R04HT

Blue Bird Body Company has decided that a defect which relates to motor vehicle safety exist in certain 2004 and 2005 model year Blue Bird All American front engine school and transit buses equipped with Option 2836-01 Driver's 3-Point Seat Belt. The subject buses were manufactured at Canadian Blue Bird in Brantford, Ontario from March 03, 2003 through April 05, 2004.

3-Point Seat Belt Fasteners

MODELS AFFECTED: 2004 & 2005 A3FE with Option 2836-01, Driver's 3-Point Seat Belt

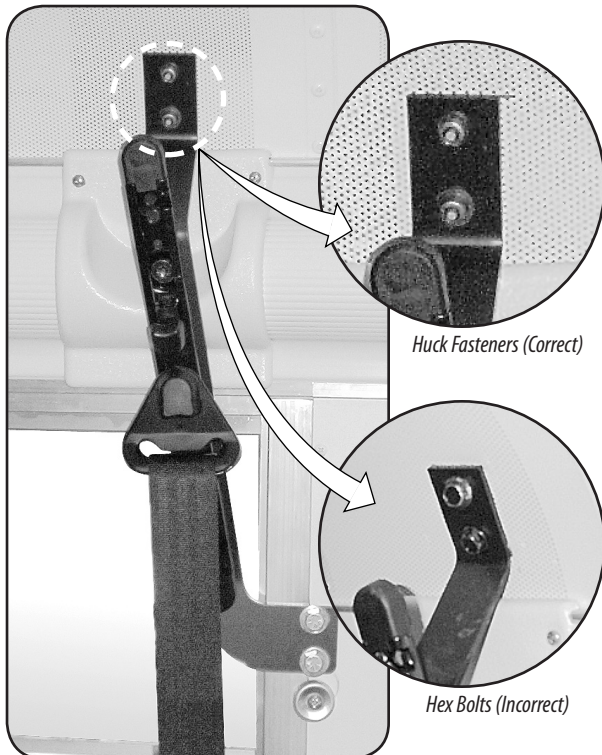
Incorrect fasteners may have been installed in upper mounting bracket of driver's shoulder belt height adjuster.

Inspect the mounting bracket fasteners. If the incorrect fasteners are installed, replace with new correct fasteners.

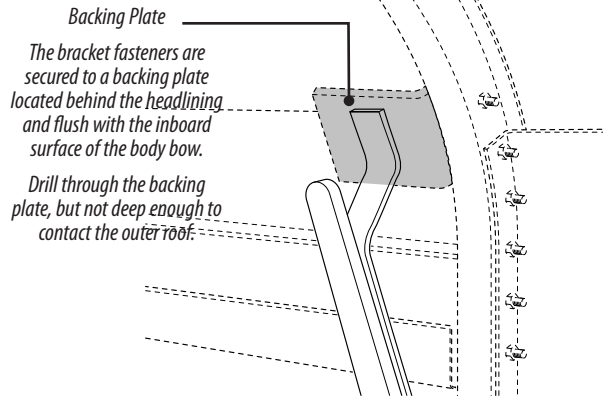
Remove two Torx fasteners to remove shoulder belt height adjuster in order to gain necessary clearance for installing Huck fasteners.

2 Remove the seat belt height adjuster bolts, using a T50 Star Bit Socket/Torx Head Bit socket.
